RECEIPT DATE: 8/11/17 **ONSITE SEWAGE DISPOSAL SYSTEM** P 561491

APPROVAL DATE: 11/30/17 **PERMIT: CONSTRUCTION** A _____

PROPERTY ADDRESS: 1824 FLORENCE ROAD, MT AIRY, MD 21771

Approved Septic System Plan
Howard County Health Department

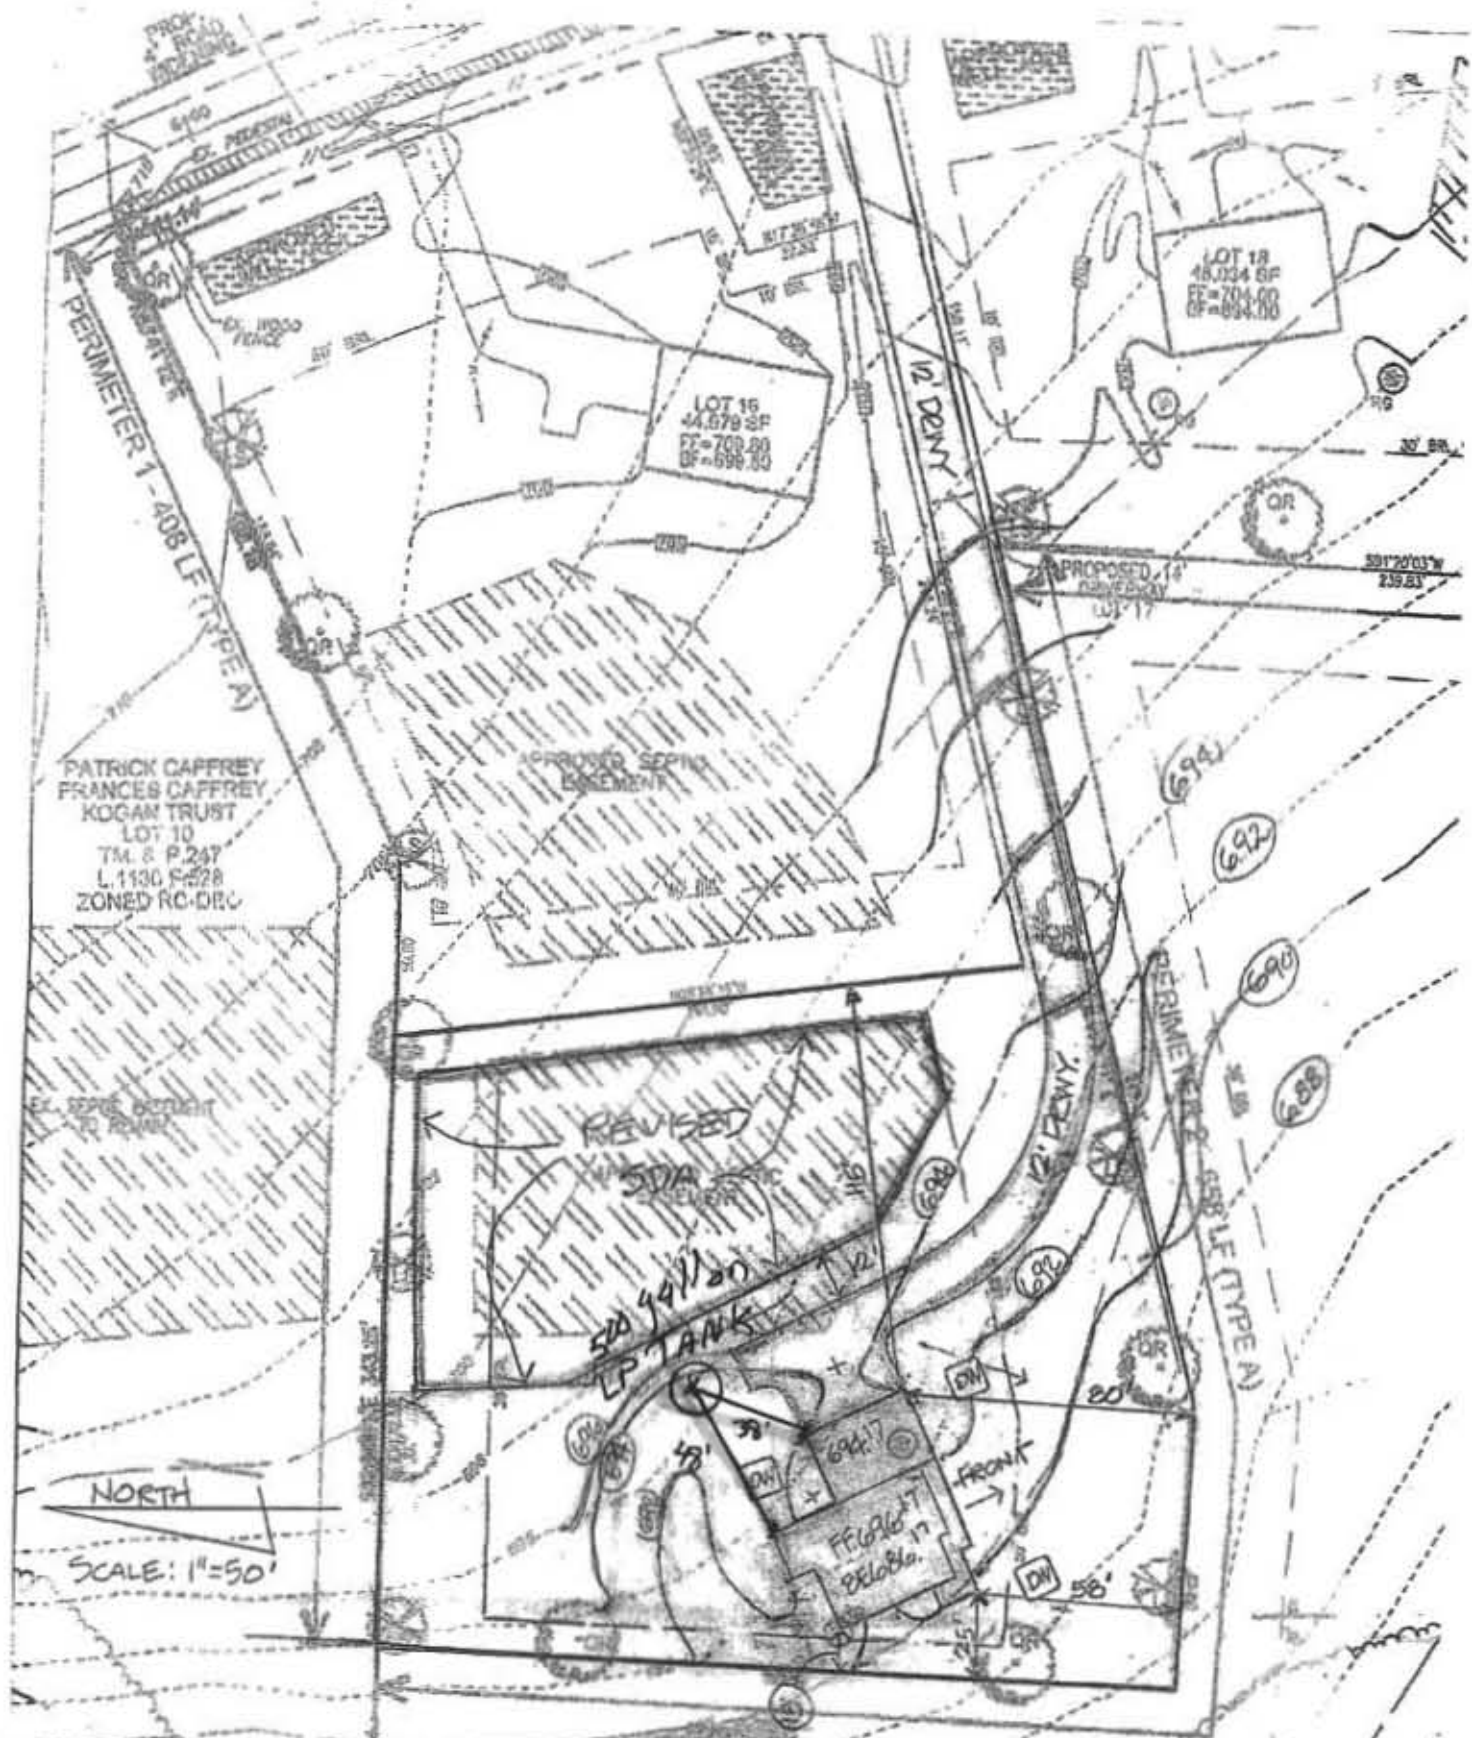
8/11/17 Met Curtis Cumberland on site for layout. SDA corners staked. Shot contour + laid out 3x60' trenches. OK to move tanks farther from house to allow space for future pool. Will need traffic-bearing lids. (SC)

8/17/17 House connection made. Septic tank set, tank hole dug but 2" too high. Lots of rock in tank holes. Curtis will dig hole deeper + set pump tank tomorrow. T1 dug + stone added - 3' wide, 4' inlet. Need observation port @ trench end. (SC) 8/18/17 observation port installed @ T1 end. T2 finished + left open @ ends - 3' wide, 3.5' to stone. Curtis adding stone to T3 - 3' wide, 4' inlet. Pump tank set. (SC) 8/21/17 D-box + force main installed. Need 6" vertical pipe on tank inlet baffle and pump and alarm. (SC) 11/30/17 On site for pump + alarm test. Audible/visual alarm at tank sounds when triggered. pump pumps effluent to D-box. (SC)

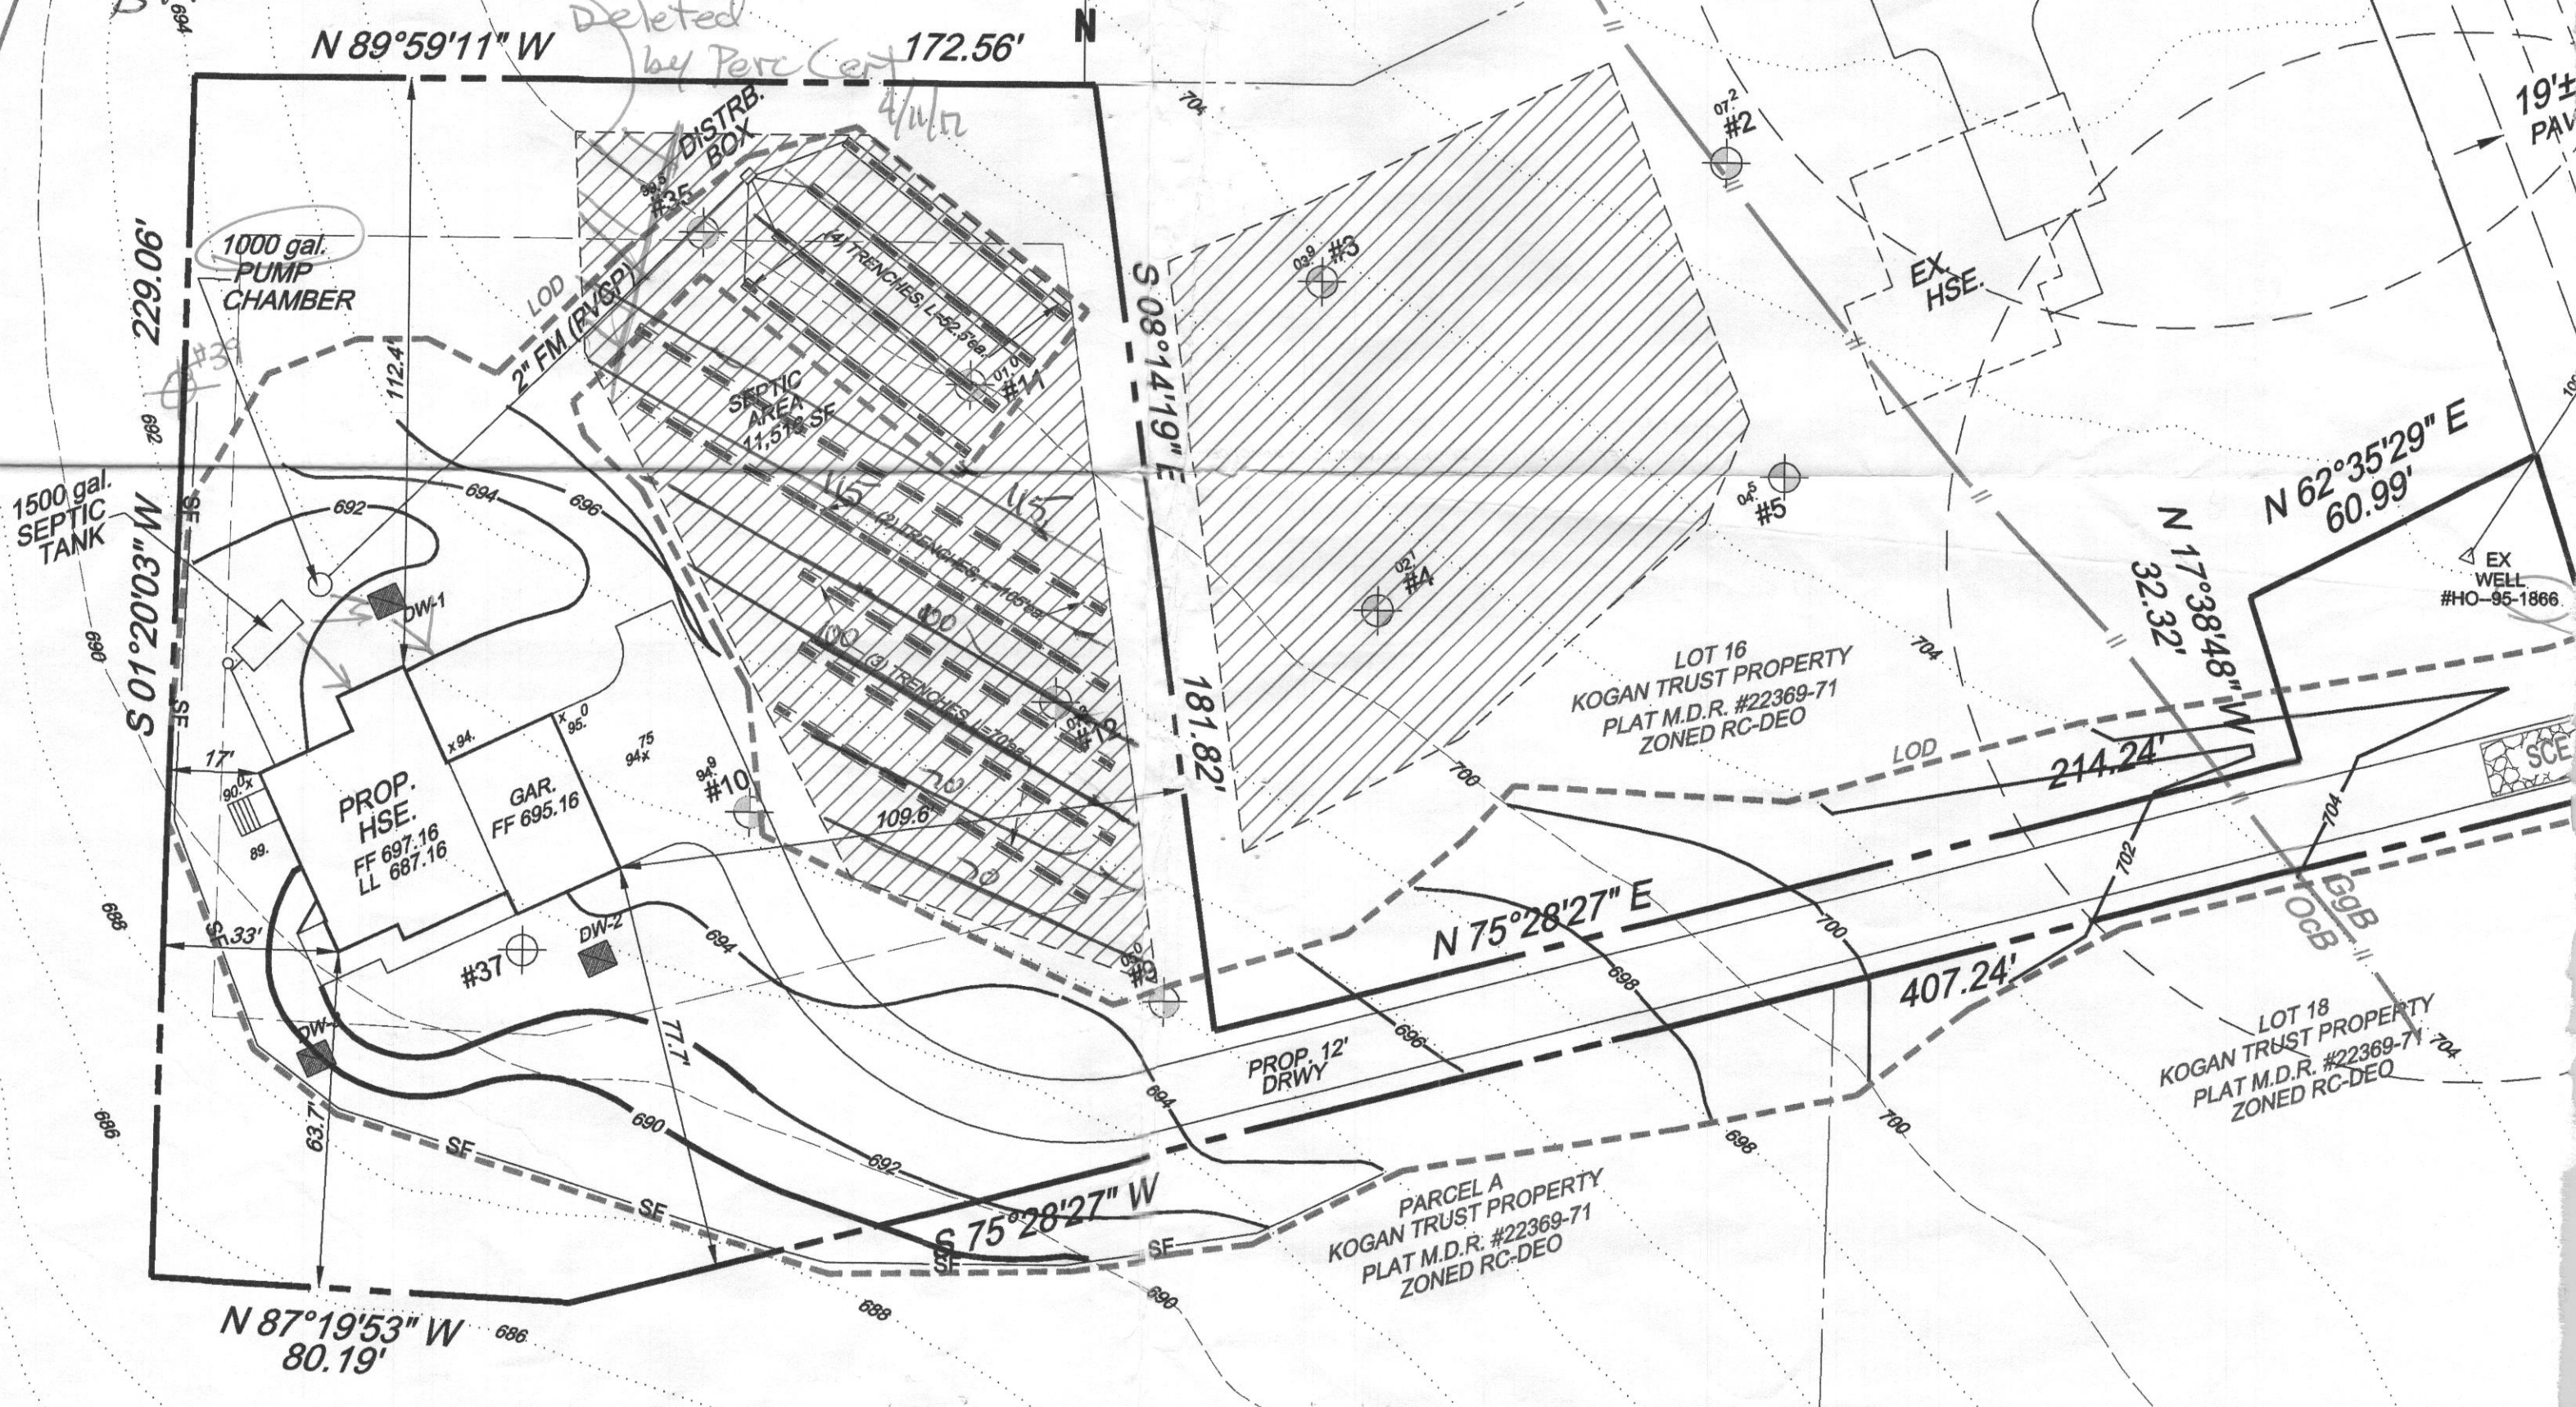
1824 Florence Road
4 Bed room SFD, Permit Plan approved
w/edits indicated
being implemented on OSDS Plan

Area Deleted by Perc Cert
